DSP-15031-01

Application	General Data	
Project Name: EZ Storage College Park Location: On the south side of Branchville Road, approximately 1,080 feet east of its intersection with Rhode Island Avenue. Applicant/Address: Siena Corporation 8221 Snowden River Parkway Columbia, MD 21045	Planning Board Hearing Date:	05/23/19
	Staff Report Date:	05/07/19
	Date Accepted:	03/18/19
	Planning Board Action Limit:	05/27/19
	Plan Acreage:	1.82
	Zone:	I-2
	Dwelling Units:	N/A
	Gross Floor Area:	122,190 sq. ft.
	Planning Area:	66
	Council District:	01
	Election District:	21
	Municipality:	College Park
	200-Scale Base Map:	210NE05

SUBJECT: Detailed Site Plan DSP-15031-01
Departure from Design Standards DDS-648
Departure from Parking and Loading Standards DPLS-459
Type 2 Tree Conservation Plan TCP2-020-2016-01
EZ Storage, College Park

RETAINING WALL

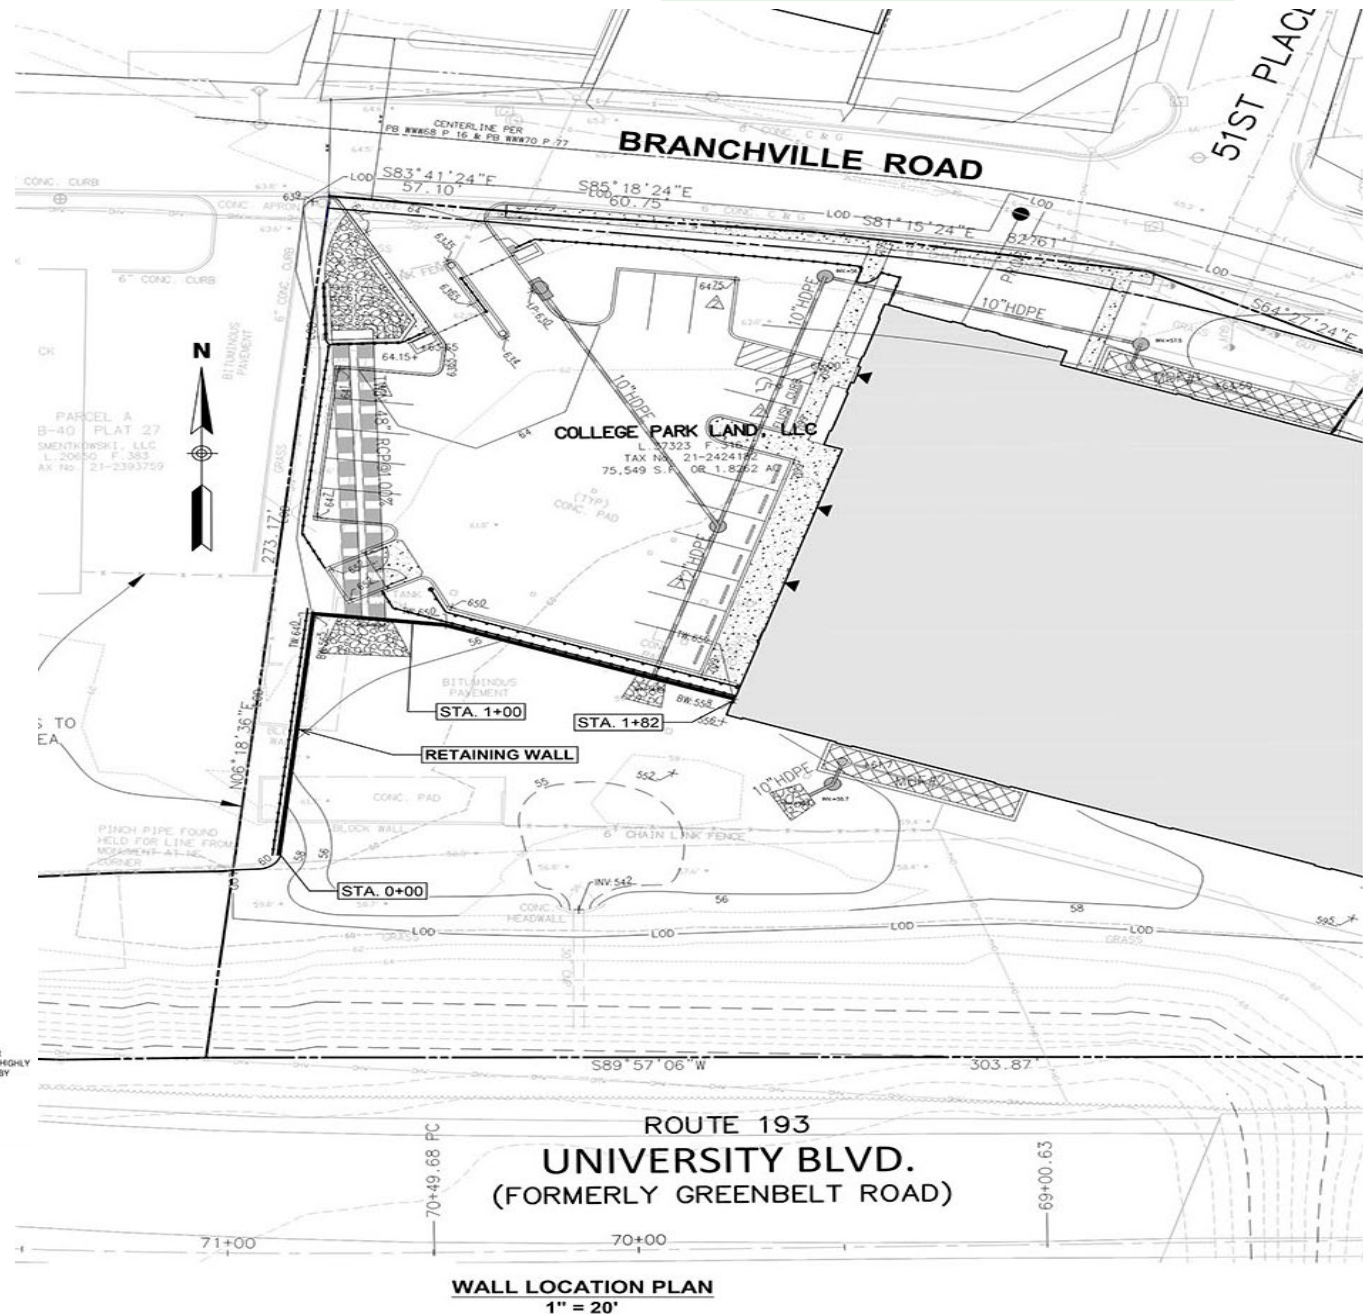
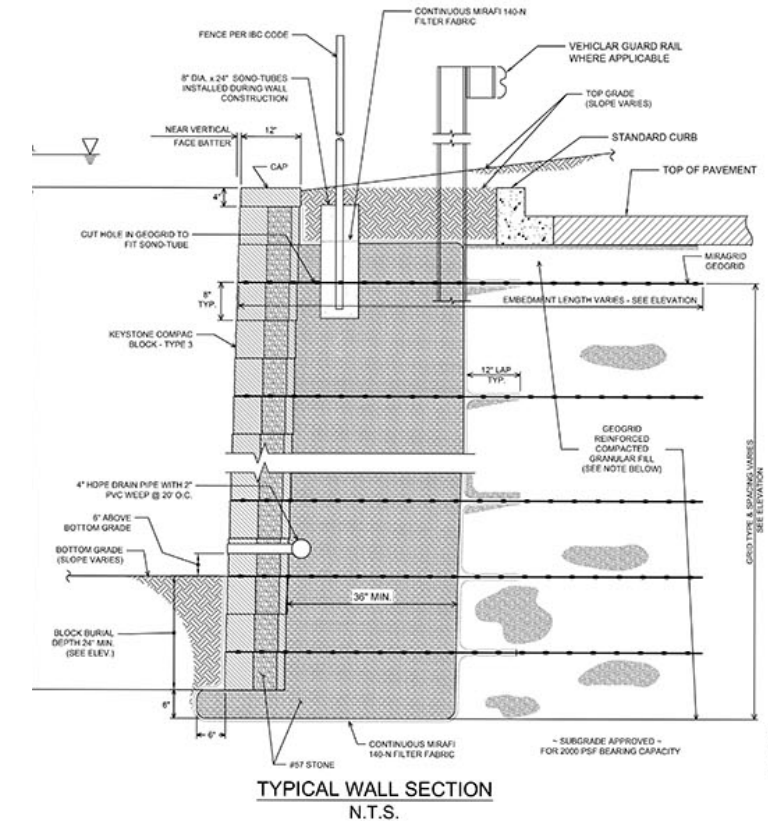
- b. Clearly show bottom wall elevations to correspond with top wall elevations on Sheet 3.
- c. The applicant should add “Handrail” to the detail title (e.g.: Key Retaining Wall Guard Rail and Handrail) on both Sheets 3 and 6.

11. List variable width of the retaining wall height on Site Plan/DSP-3 or Detail Sheet/DSP-6, #6. And in the Typical Wall Section Detail on Sheet 1 of 2 of the Retaining Wall Construction Details sheets.

12. Since applicant included the handrail in the Key Retaining Wall Guard Rail Detail #6 on sheet DSP-6, then applicant should add “Handrail” to the detail title. (e.g.: Key Retaining Wall Guard Rail and Handrail) on both the DSP (Sheet DSP-3) and the Detail Sheet (DSP-6).

13. In reference to the handrail in No. 5, above, Detail #6 on DSP-6 states, “Height as indicated on plan”. Height of the handrail is not indicated on the plan, however. Include the height in the detail or on the plan.
